MU-4 Zoning District - ZONING APPROVAL for the INTERIOR RENOVATIONS to an existing Single-Family Row Dwelling and Change-of-Use to a TWO-FAMILY FLAT per submitted plans. NO OTHER WORK AUTHORIZED UNDER THIS PERMIT.

527 FLORIDA AVENUE NW WASHINGTON, DC 20001

C001
Board of Zoning Adjustment
District of Columbia
CASE NO.2167
EXHIBIT NO.02

proposed floor plans
527 FLORIDA AVE NW, WASHINGTON, DC 20001

second
proposed floor plans

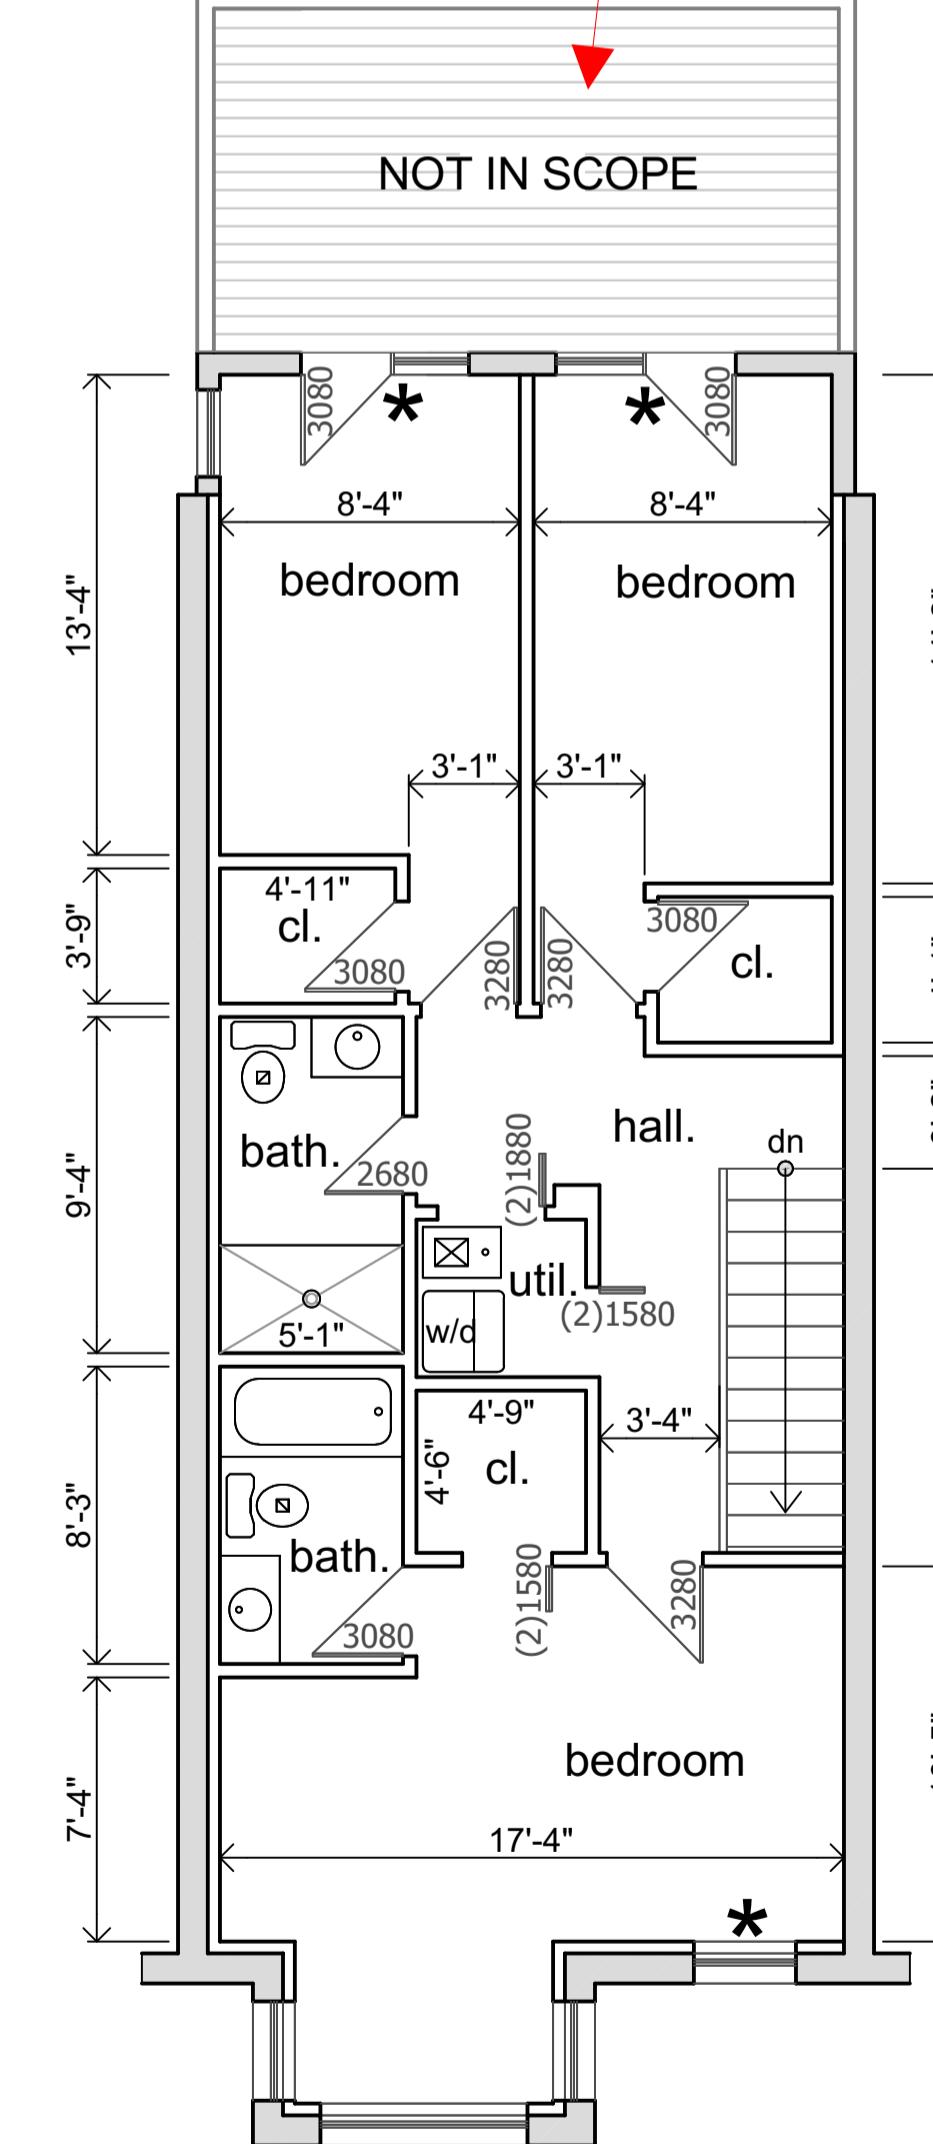
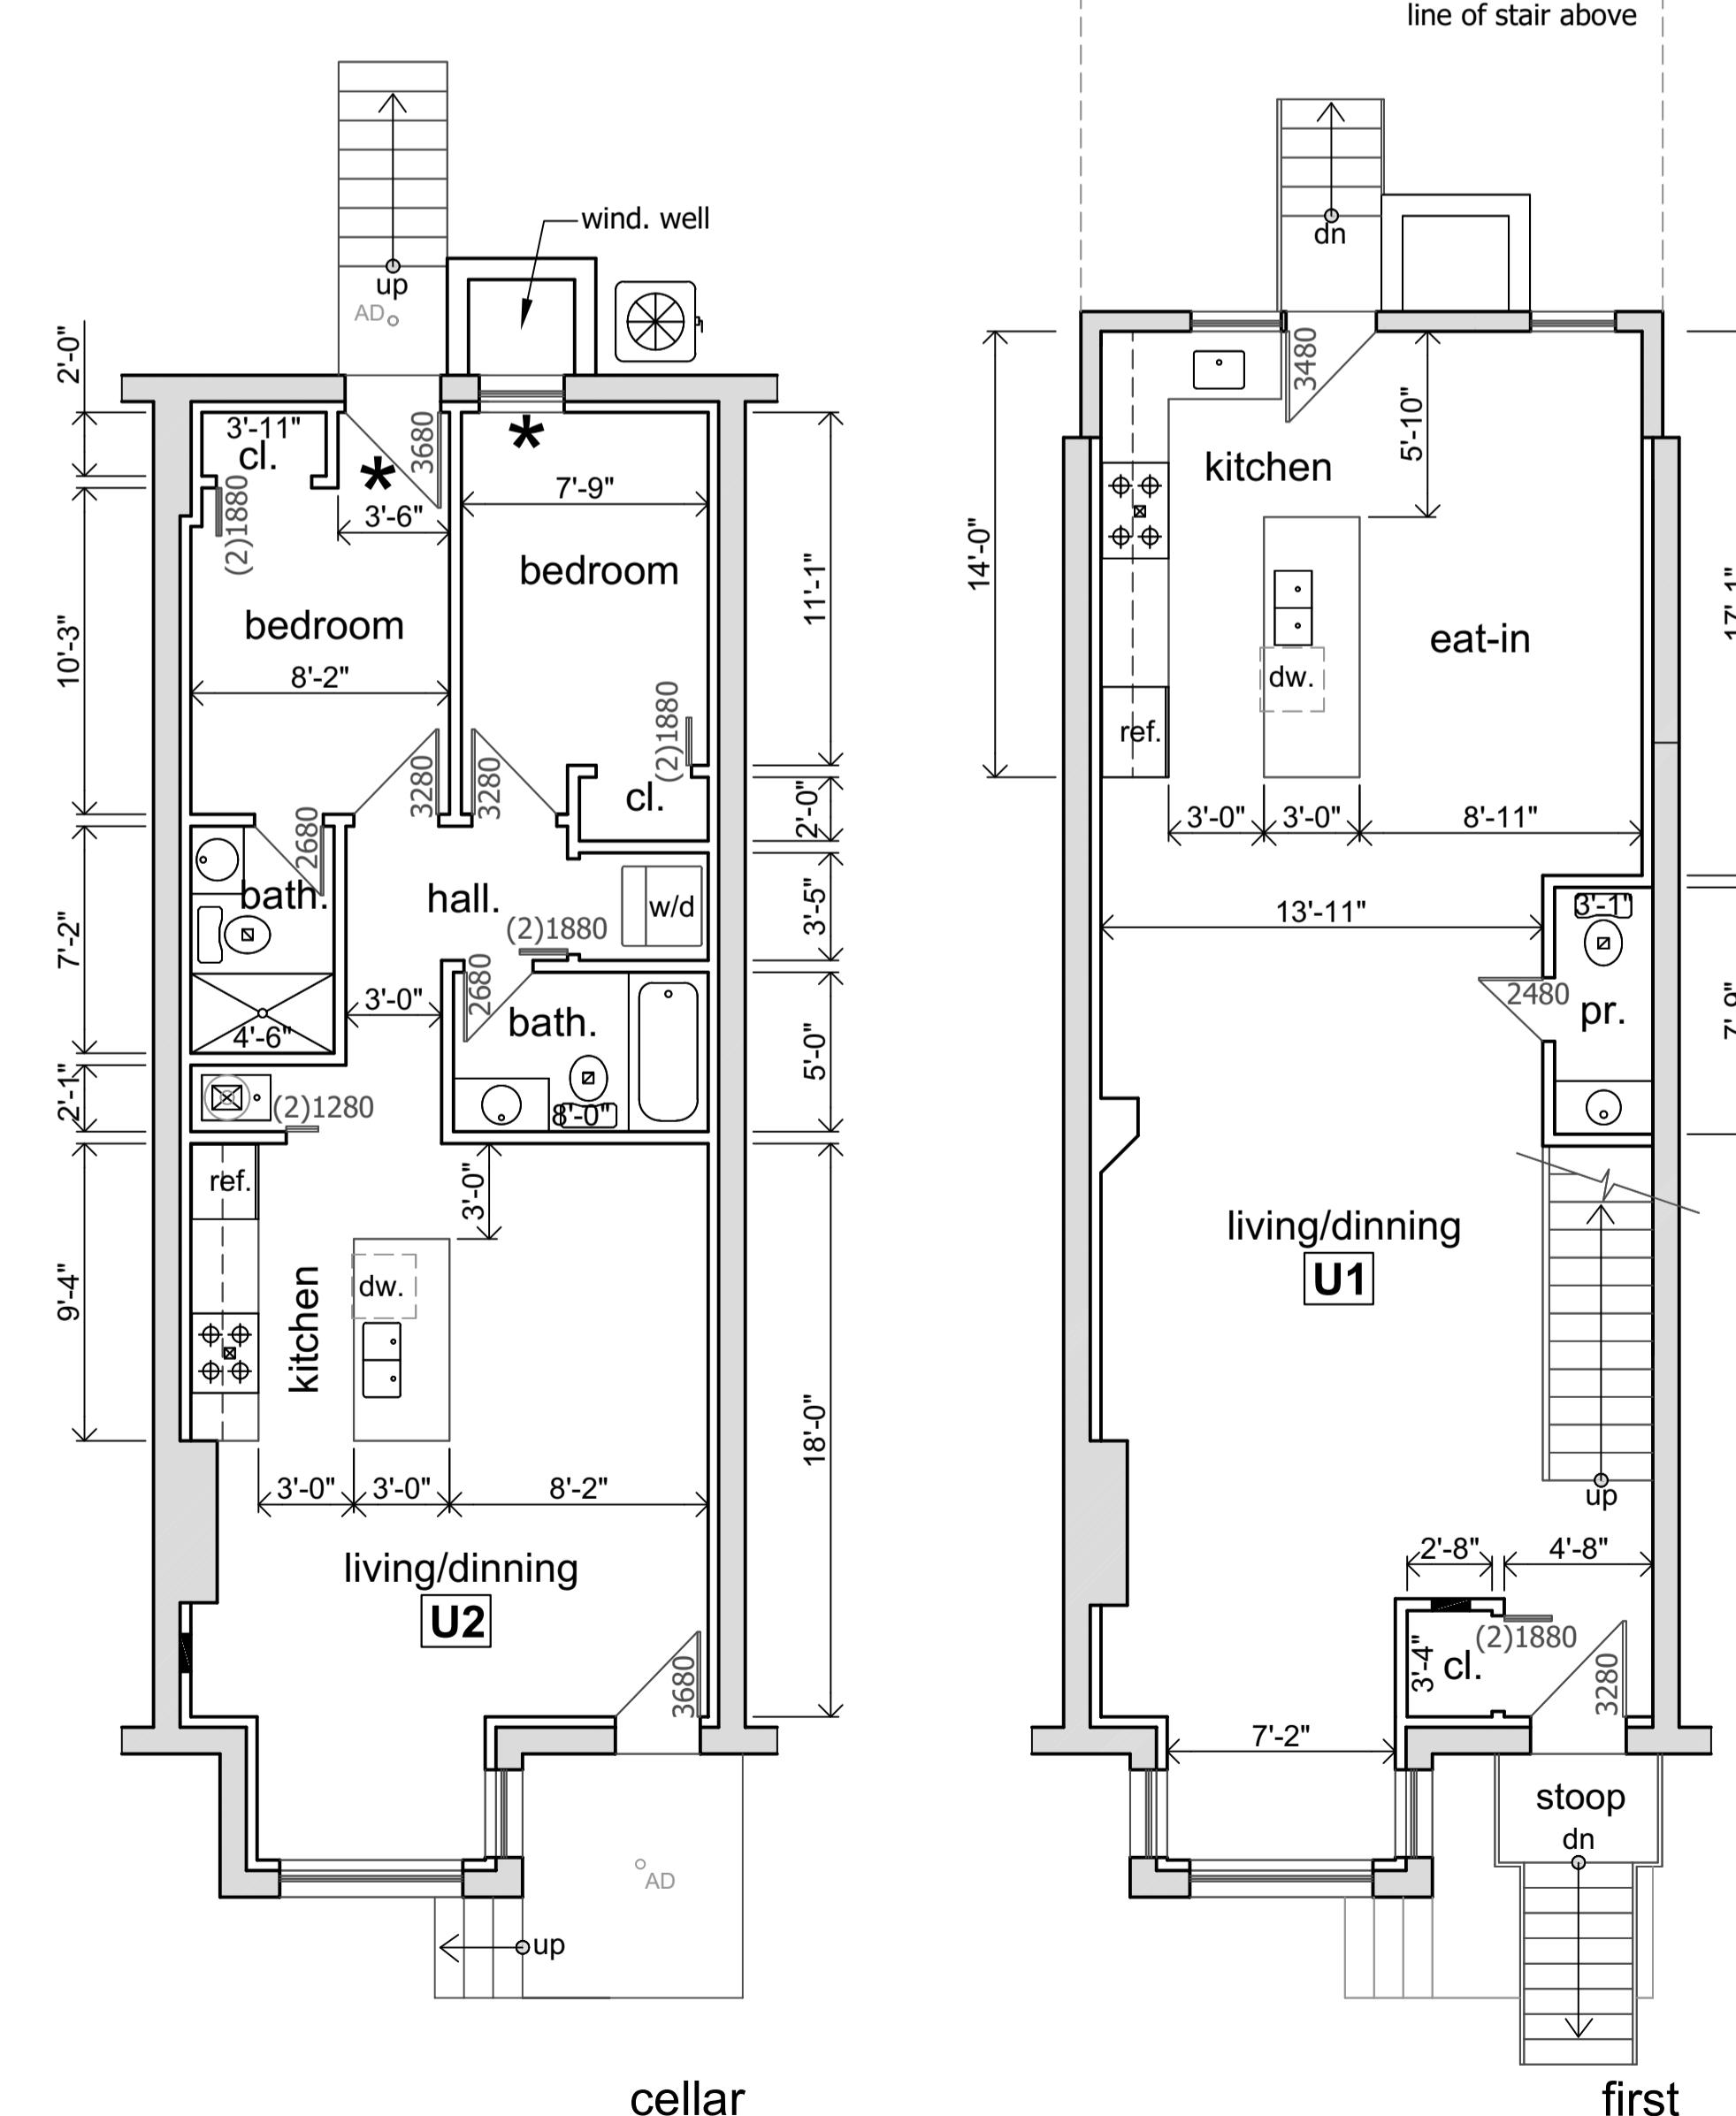
- REAR DECK: Non-Conforming Rear Deck is subject to Stop-Work-Order
23ENF-IC-03465: Rear deck is not included or authorized in the scope of work of this permit and requires relief from the Board of Zoning Adjustment. Applicant must obtain a building permit for the rear deck
